6. 236 Union Street

Status: Field Changes / Compliance Issues – Minor Project

236 Union Street

Land Use Compliance Review

A-0.7

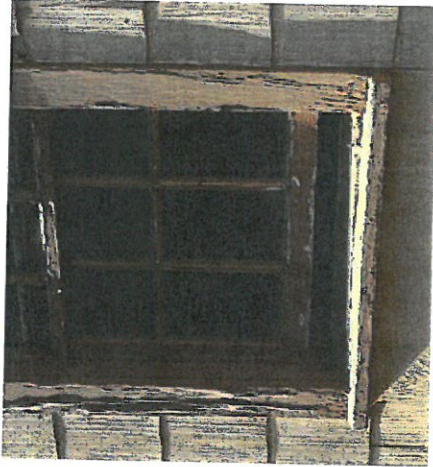
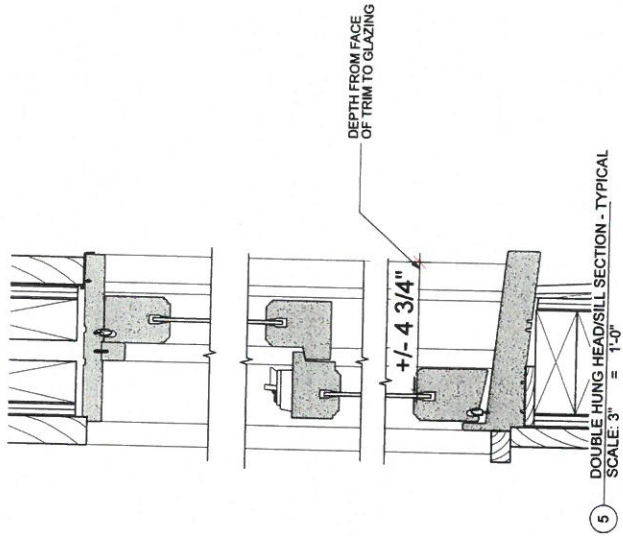
02-03-16 Historic District Commission Approval: Sheet A-0.7

1. Casing is uniformly 3.5" (see item 4). ← Please Approve modification

A-2.1a

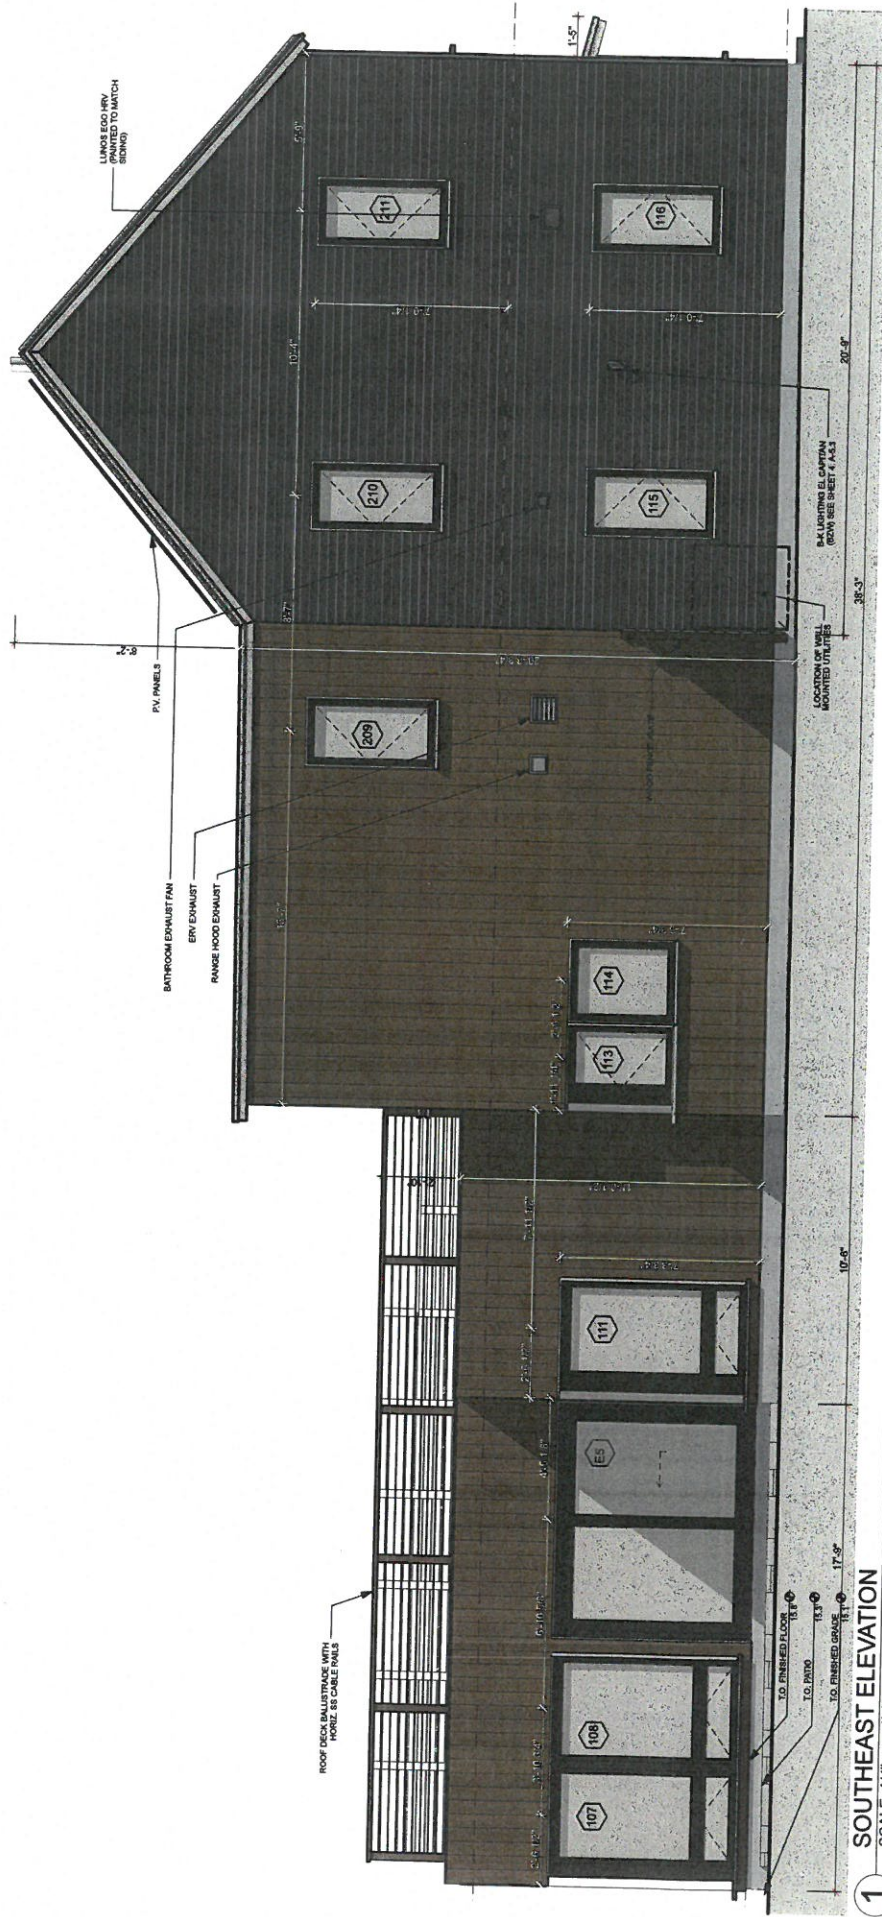
02-03-16 Historic District Commission Approval: Sheet A-2.1a

1. Granite steps changed to concrete. ← Changed per request from owner, seeking approval.
2. Rooftop baluster with cables deleted. ← To be installed at later date.
3. Acetylated wood jamb extension on eave window head detail deleted (see Sheet A-5.1).

- A. Wooden fence/gate. ← To be installed at later date.
- B. Parge coating on concrete wall. ← Deleted
- ~~C. Break metal wrapped fascia and rake on awning (see Sheet A-2.1a).~~

A-2.2a

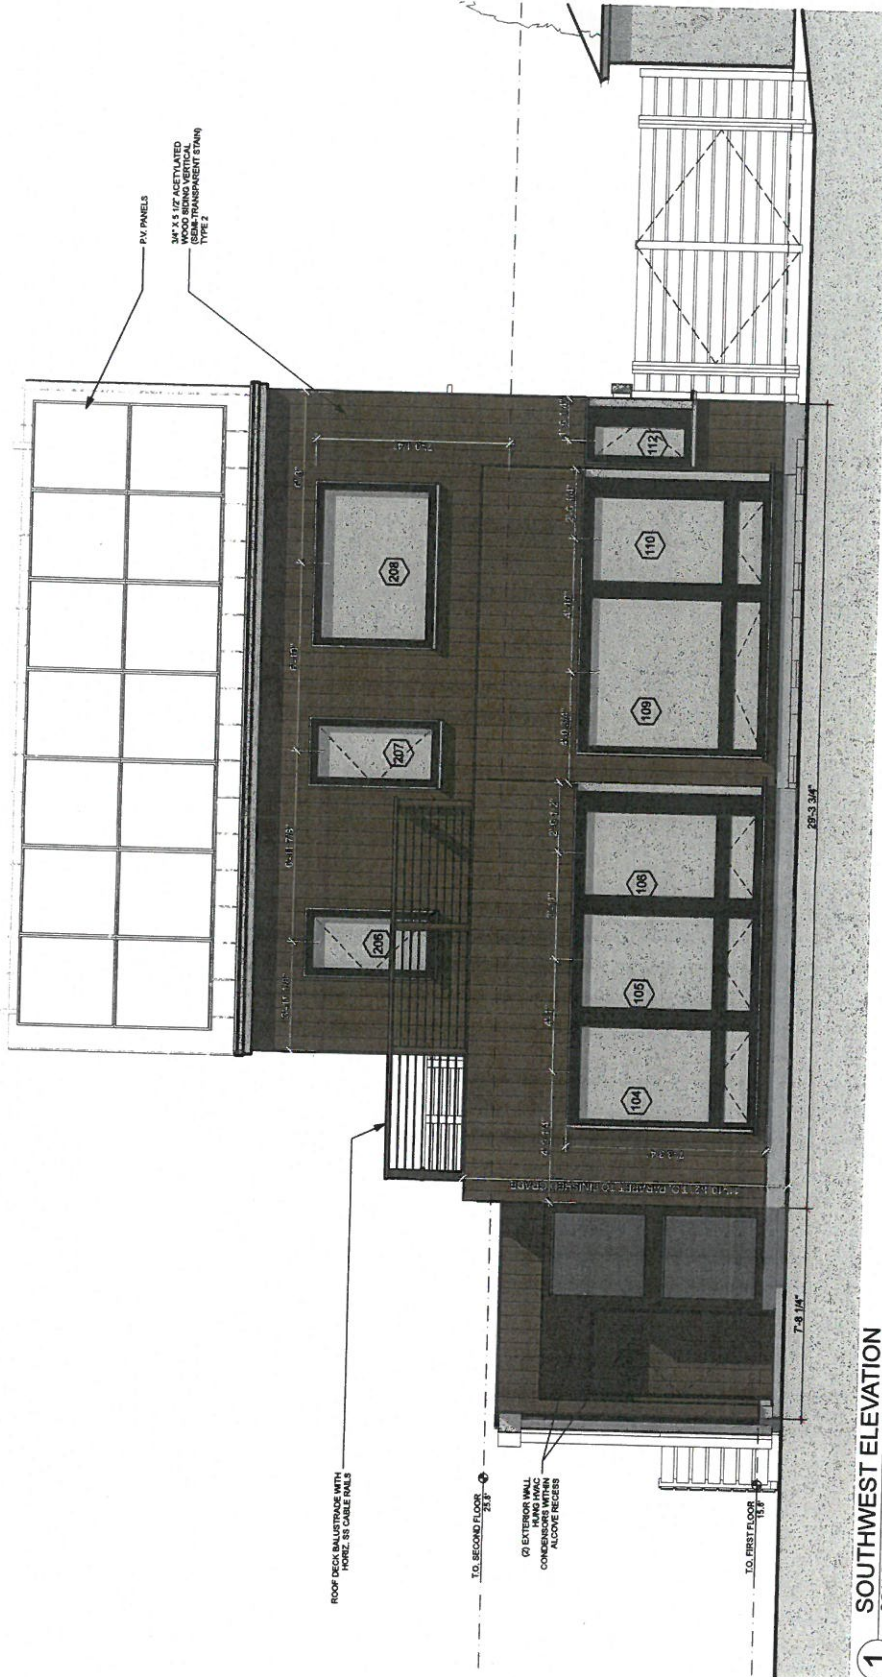
02-03-16 Historic District Commission Approval: Sheet A-2.2a

1. Additional gas meters added. ← 2 unit building, needs 2 meters, only place they could go, seeking approval
- ~~2. 113 window increased in dimension (now dimensioned the same as 114 window). UPDATE: approved administratively 9.22.16~~
3. 111,107,108 window bottom lights increased in dimension. ← Sizes changed to fit standard offering from window manufacturer, seeking approval

- A. 209 window sill.
- B. Horizontal cladding.
- C. Vertical cladding.

A-2.3a

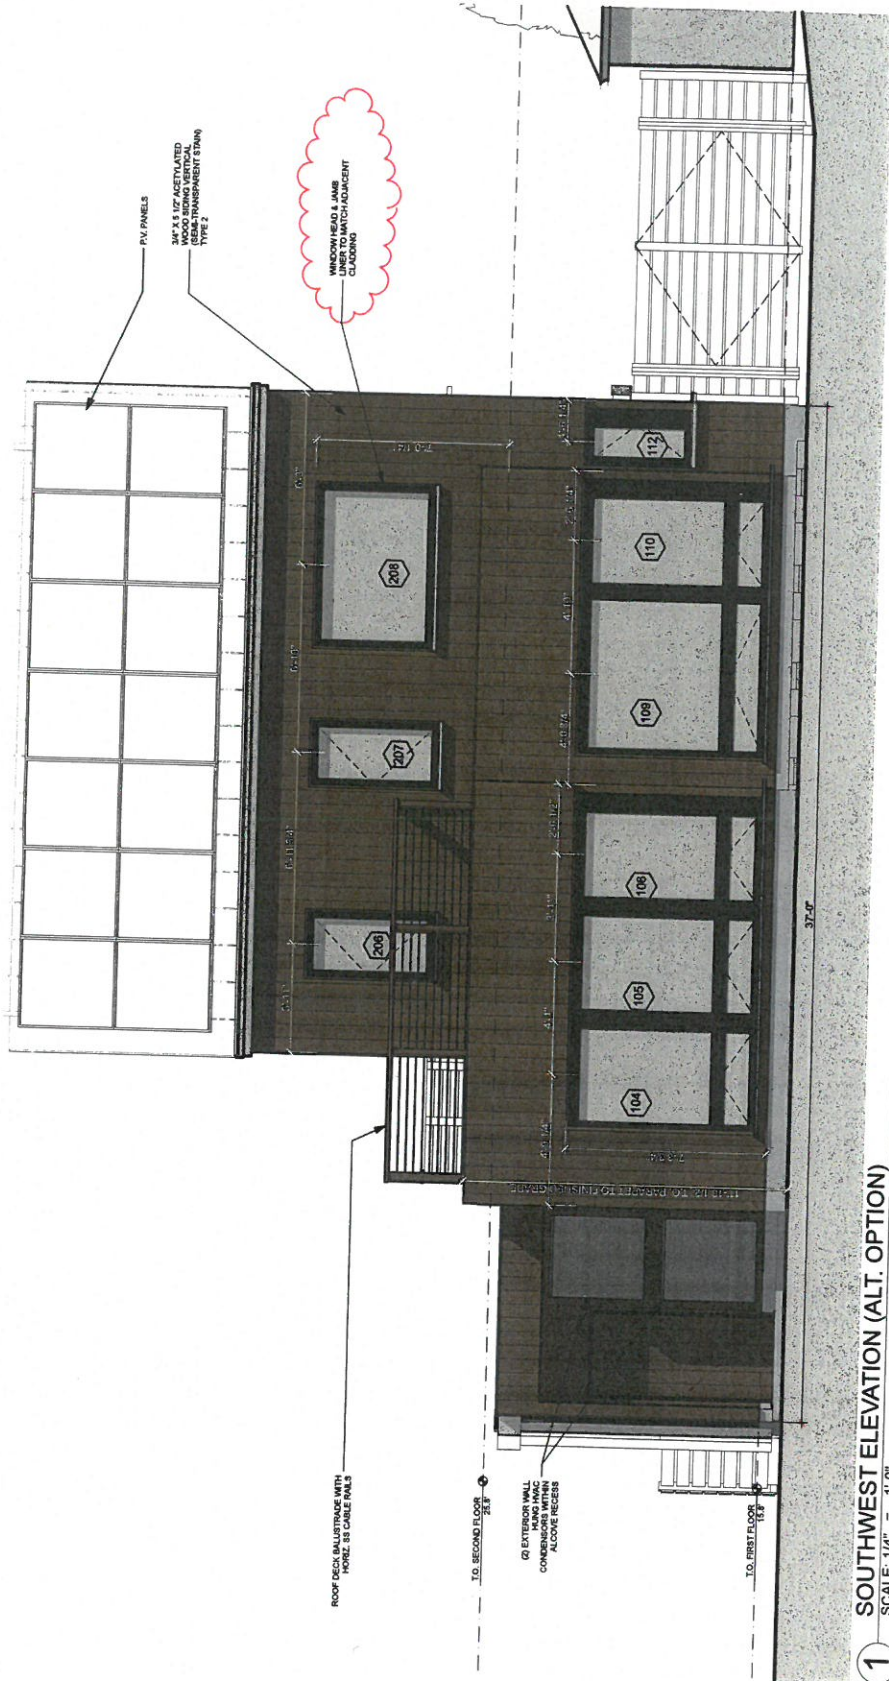
02-03-16 Historic District Commission Approval: Sheet A-2.3a

1. Vertical cladding.

- A. ~~208 window now divided by mullion. UPDATE: approved administratively 9.22.16~~
- B. ~~Additional mullion creating third bottom light for 109 and 110 windows. UPDATE: approved administratively 9.22.16~~
- C. Bottom lights increased in dimension for 104,105,106 windows.

PREVIOUSLY APPROVED PLAY YARD ELEVATION

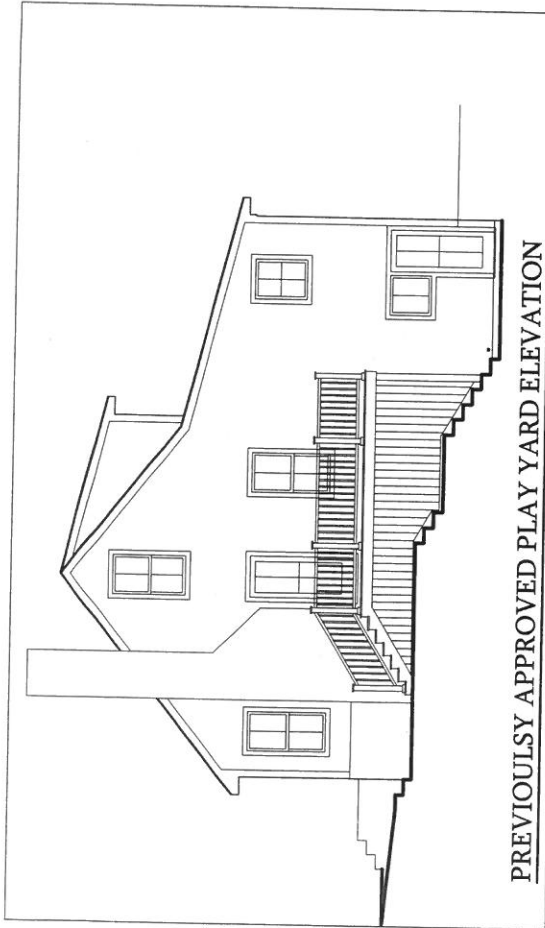
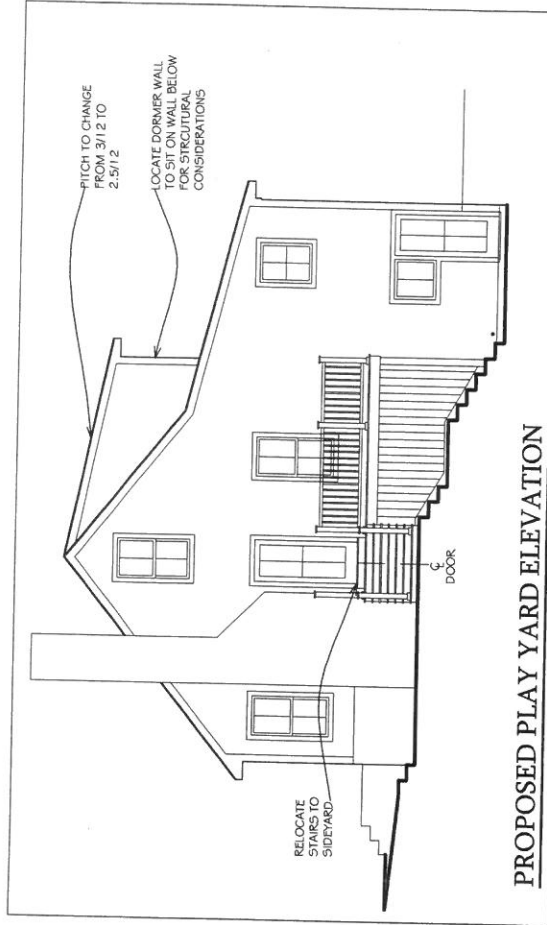
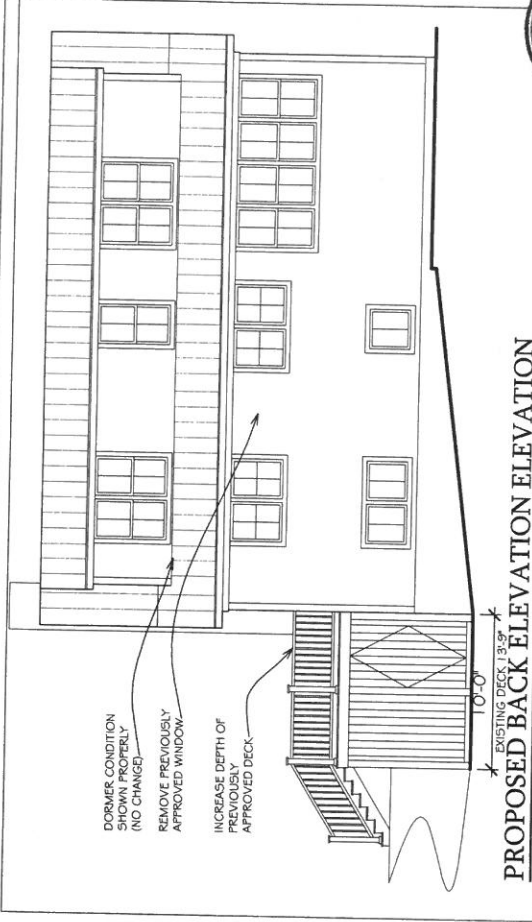
Background: The HDC recently approved this project and the applicant is requesting to increase the depth of the proposed deck, relocate the stairs, remove a window proposed for the kitchen and clarify the dormer detail for the side elevation.
